**TOWN OF NEWBURGH  
PLANNING BOARD  
TECHNICAL REVIEW COMMENTS**

**PROJECT NAME:** GARDNER RIDGE  
**PROJECT NO.:** 02-29  
**PROJECT LOCATION:** GARDNERTOWN ROAD NEAR GIDNEY AVENUE  
SECTION 75, BLOCK 1, LOT 4.12  
**REVIEW DATE:** 10 NOVEMBER 2023  
**MEETING DATE:** 16 NOVEMBER 2023  
**PROJECT REPRESENTATIVE:** DARREN DOCE, P.E.

Re: ***Gardner Ridge***  
Gardnertown Road  
Section 75, Block 1, Lot 4.12

Gardner Ridge  
Town of Newburgh, Orange County, New York  
Colliers Engineering & Design Project No. 14000375B

**ENTRANCE ROAD (2)**  
SCALE: 1"=4' VERT.  
1"=40' HOR.

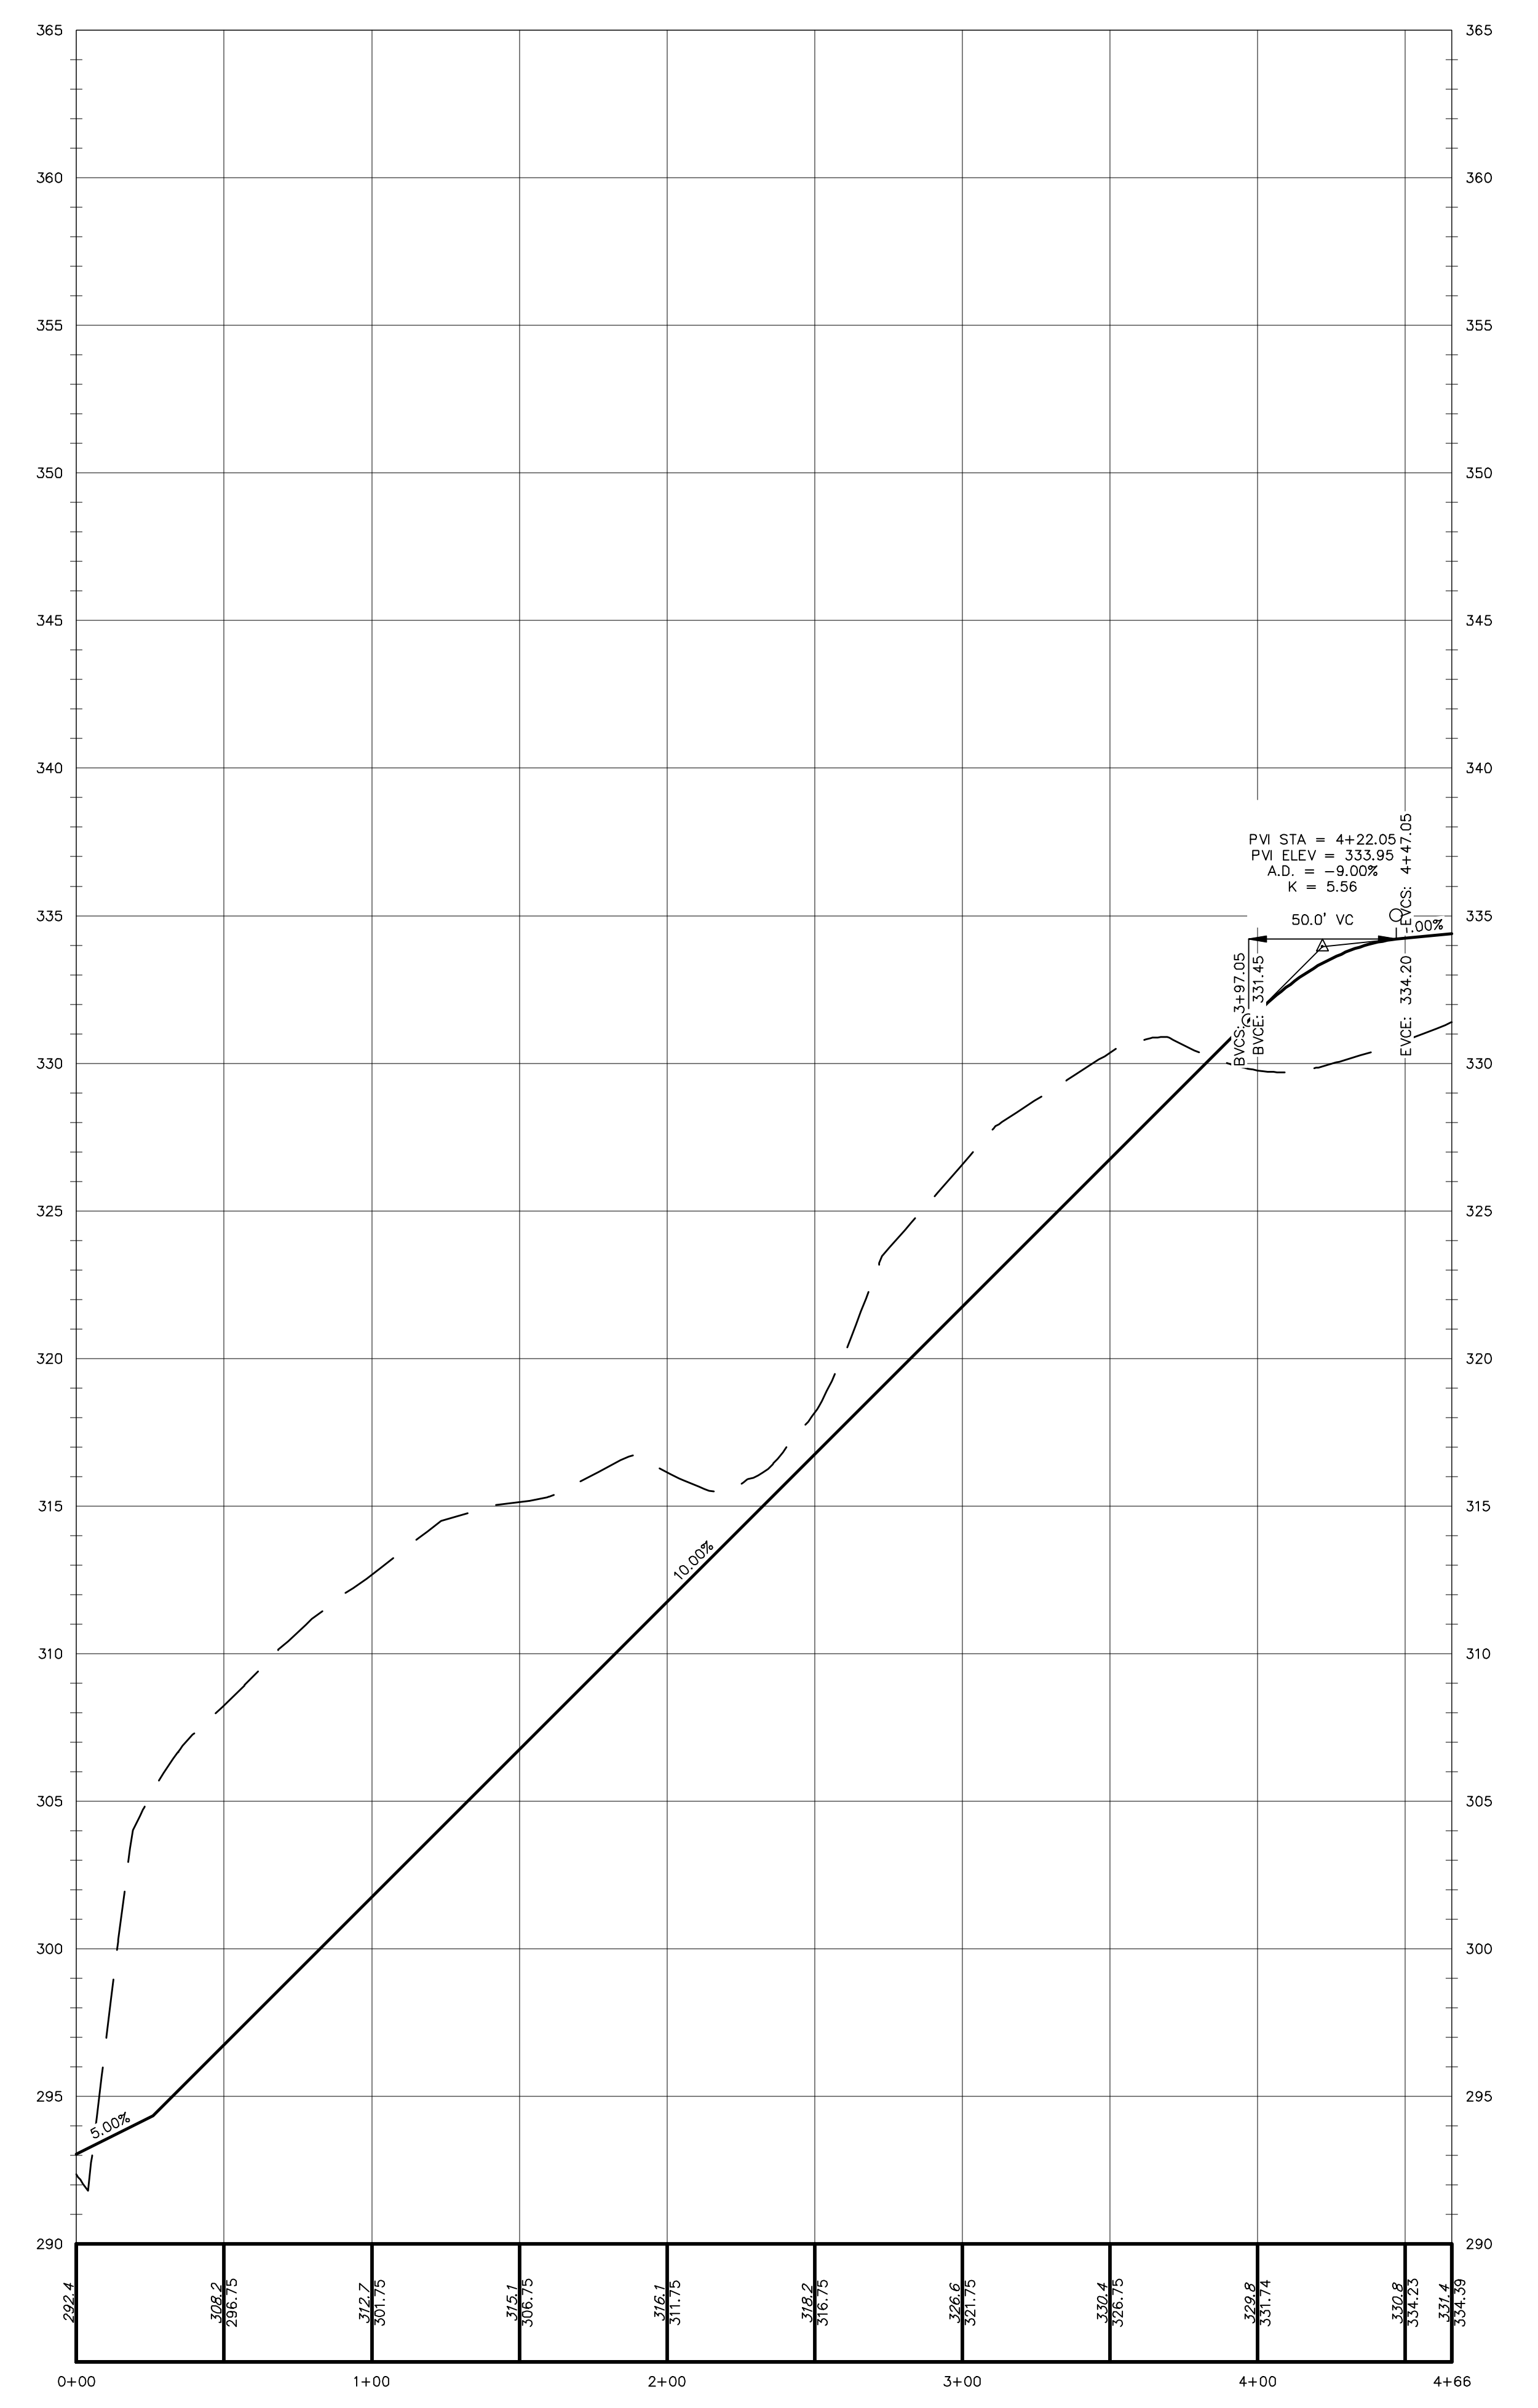
3. The junction of the Entrance Road intersects the West Road at station 12+50(+/-) where the grades transition from a +10% to a +1% grade. West Road enters on a -10% grade. Consider super elevating the road to be reverse crown, banked 2% to the left so it is an easier transition from West Road to Entrance Road.

4. Add callout to Entrance Road profile showing location of intersection with West Road.

**Response: The site plan has been revised to reflect the superelevation for that portion of the road.**

**Response: The callout has been added to the site plan.**

**VEGETATION STABILIZED SLOPE**  
NOT TO SCALE

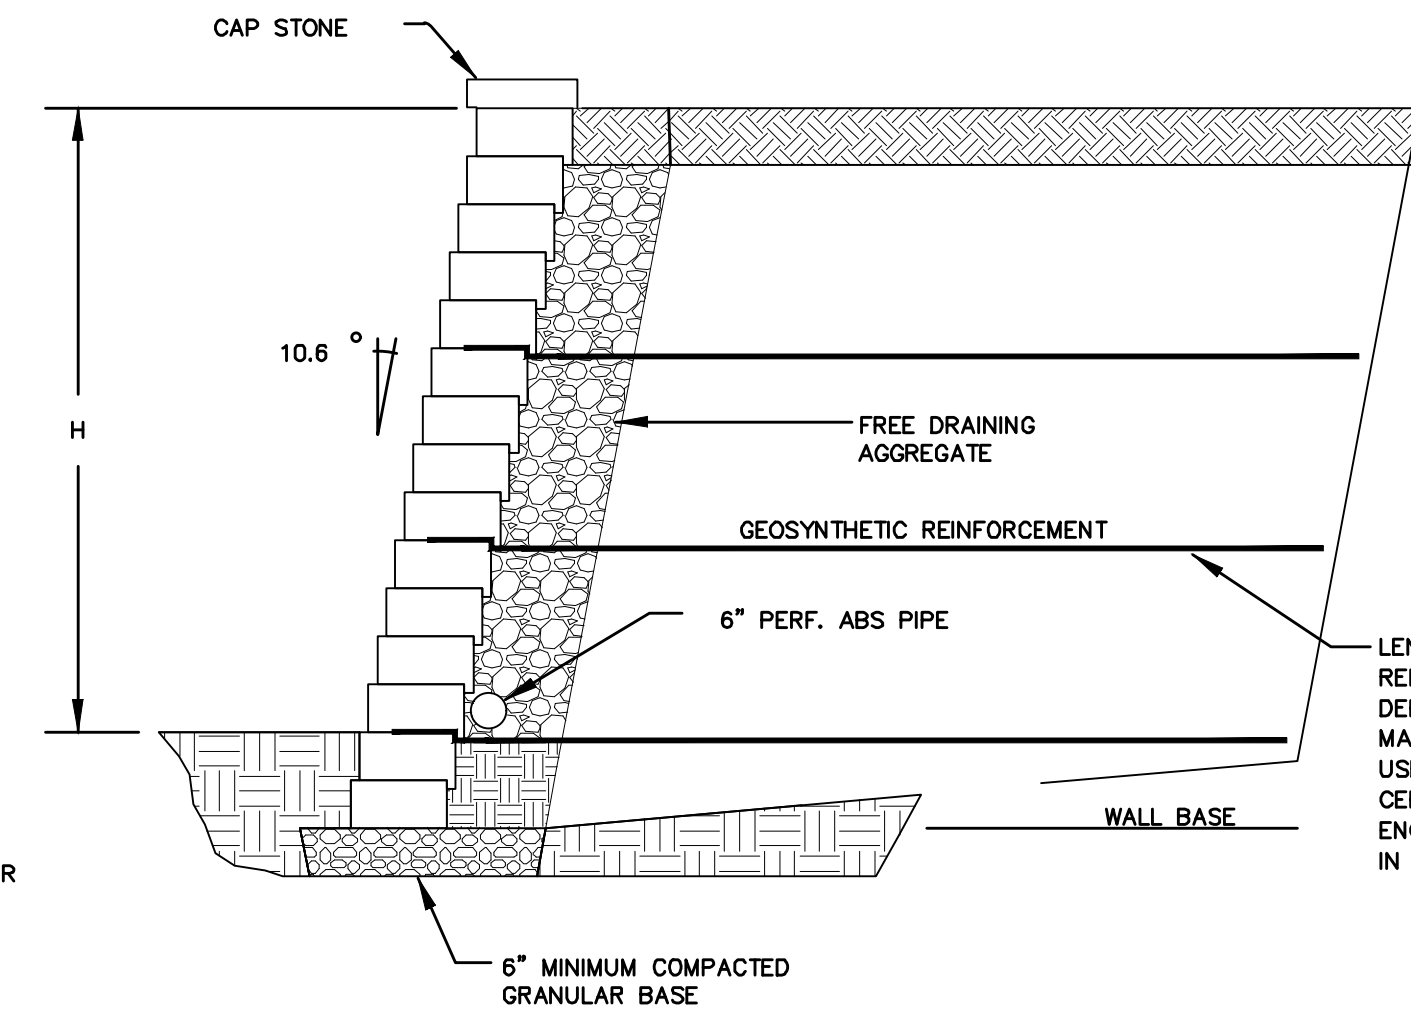
- Ken Mennerich – Recommended that instead of the riprap that a vegetative alternative be explored.

21. The sewer line to the rear of Buildings 1 and 2 has been fully labeled.
22. The rip-rap steepened slope has been redesigned as a vegetated steepened slope.

**Response:** The rip rap has been removed from the plans. We will finalize the treatment in this area with the Highway Superintendent to ensure that nothing significant will grow in that area to block sight distance.

**EMERGENCY AND MAINTENANCE ACCESS GATE**  
NOT TO SCALE

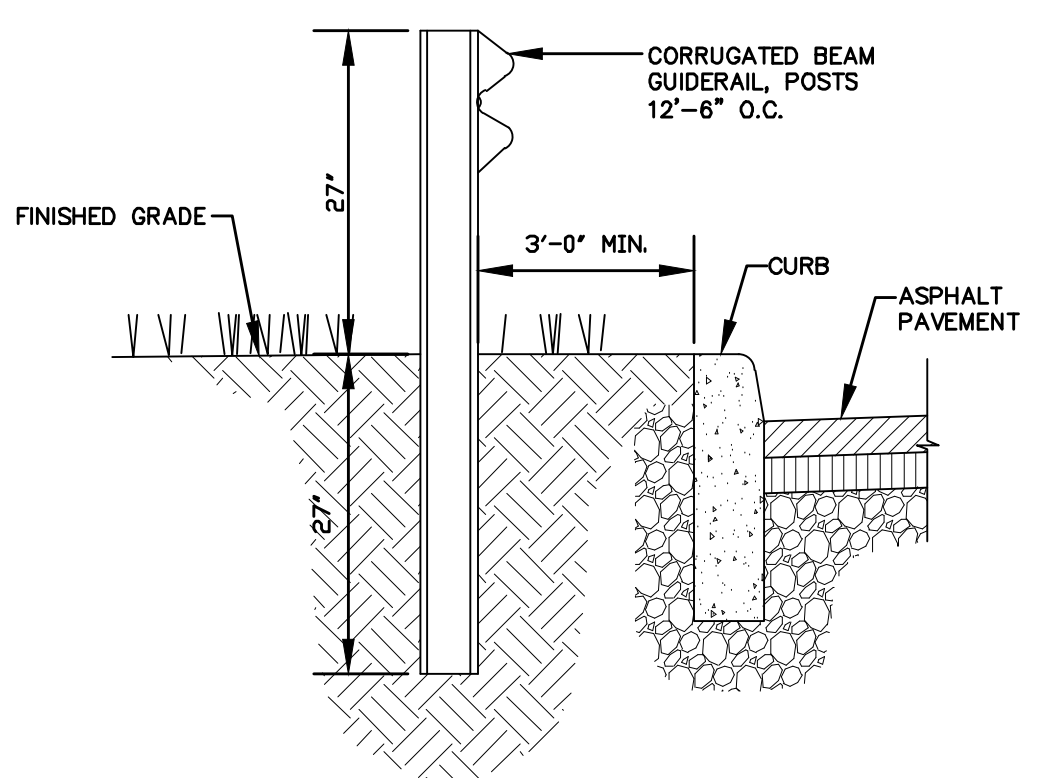
1. The revised site plan adds an emergency access point approximately 440 feet west (uphill) of the main entrance. The access is proposed to be grass pavers similar to that used across the street at Gardnertown Commons (Farrell). A detail of the emergency gate is provided, and it is noted in the letter to the planning board that there will be a gate installed at both ends of the emergency access, but they are not depicted on the plans. We suggest the gate near Gardnertown Road be located far enough off the road to allow an emergency vehicle to pull off the road before stopping and opening the gate.

2. A stormwater basin access road is proposed about 60 feet east (downhill) of the main entrance. This will be a stabilized but grassed access "road". Will this be gated as well? If so, the gate should allow room for a service vehicle to pull off the road to open the gate.

**Response: The gates and detail for such are now indicated on the site plans. The gate on the Gardnertown Road side is positioned to allow a fire truck to pull in off the road when opening the gate.**

**Response: A gate will be installed as noted at this location.**

SHEET TITLE:  
WORK ZONE TRAFFIC CONTROL  
CREEK RUN ROAD SHORT TERM  
CLOSURE DETOUR PLAN

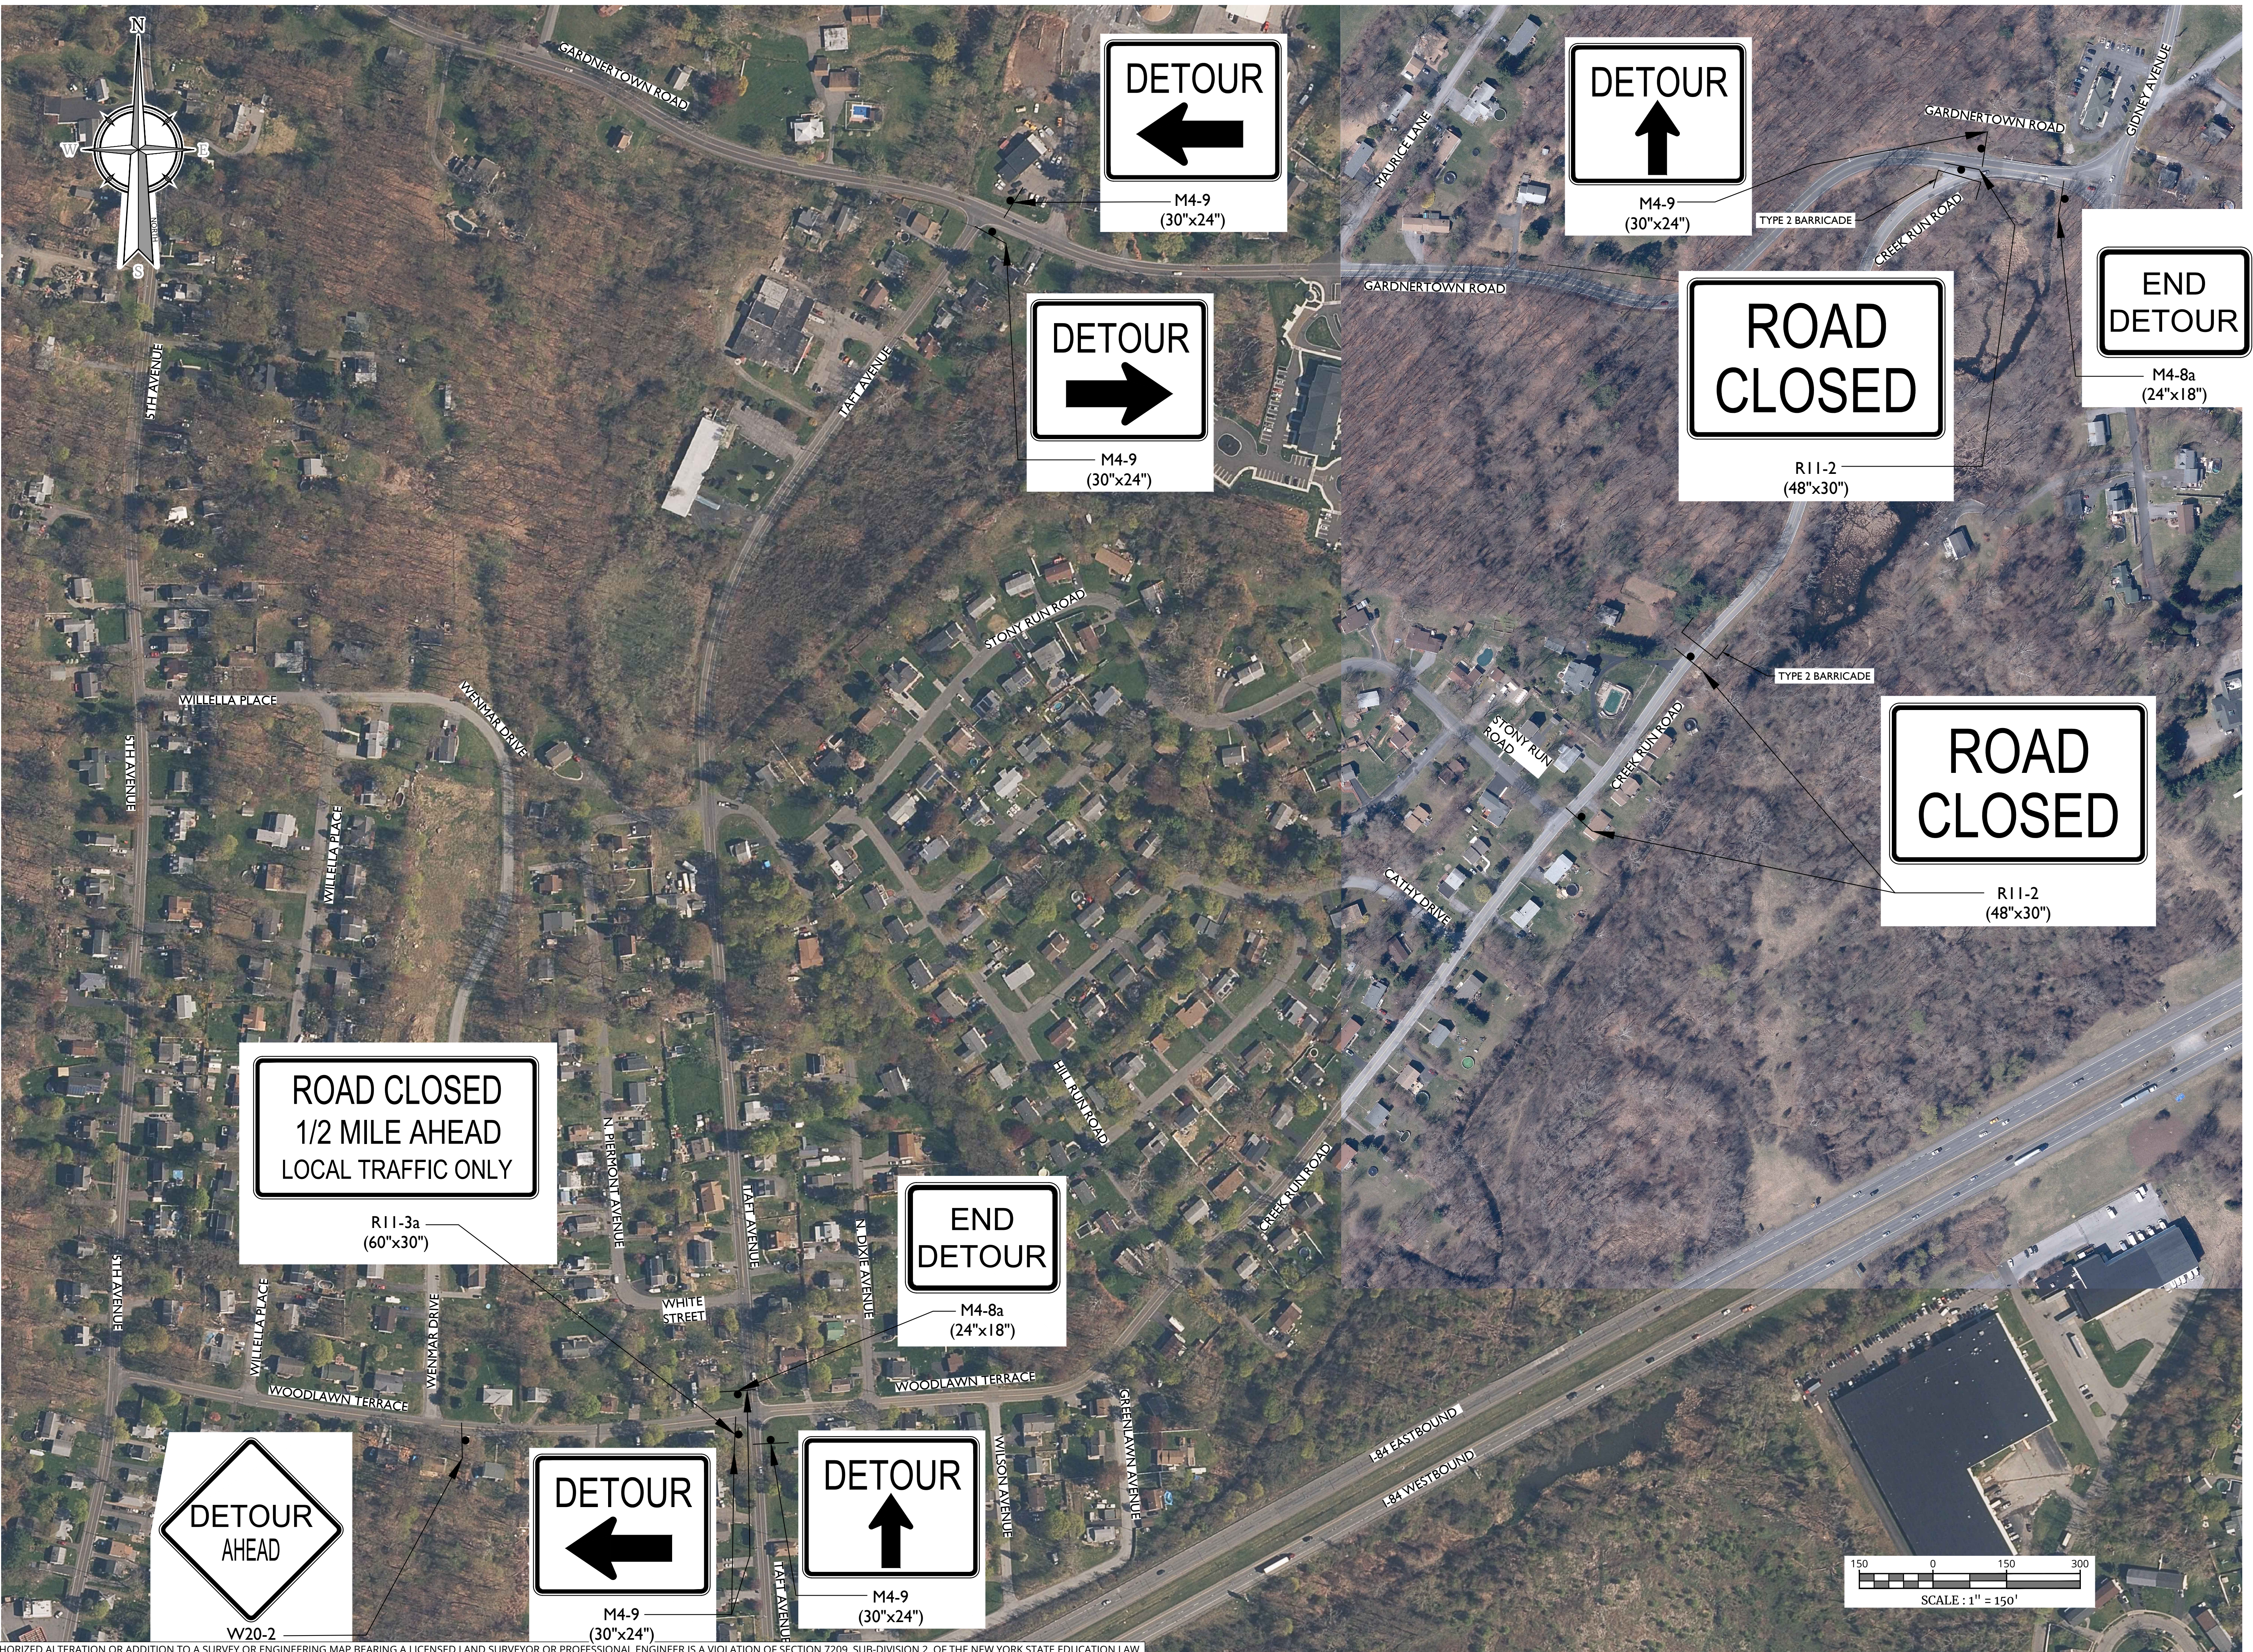
7. A detour plan is provided for when Creek Run Road is closed to be reconstructed between Stony Run Road and Gardnertown Road. What is the approximate duration of closure?

8. Taft Ave is the primary route for eastbound and westbound traffic on Creek Run Road. Road names should be labeled on the plan.

9. Consider a "Road Closed ½ Mile Ahead, Local Traffic Only" or a "Road Closed to Thru Traffic" sign at Creek Run Road and Taft Ave. Consider a "Detour [Straight Arrow]" sign on the Taft Ave NB approach to Creek Run. Consider a second "Road Closed" sign on Creek Run Rd at Stony Run Rd to deter drivers from reaching the actual hard closure and turning around in the driveway of house #42 and #44. The six houses beyond this intersection can drive around it.

**Response: Most of the work for the realigned Creek Run Road can be advanced while maintaining the existing roadway operation. The final work connecting the new portion of roadway to the remaining existing portion of Creek Run Road is expected to require a closure for less than a week to complete and open it again to traffic.**

**Response: Road names have been added to the detour plan.**

**Response: The recommended signing additions have been added to the revised plans.**
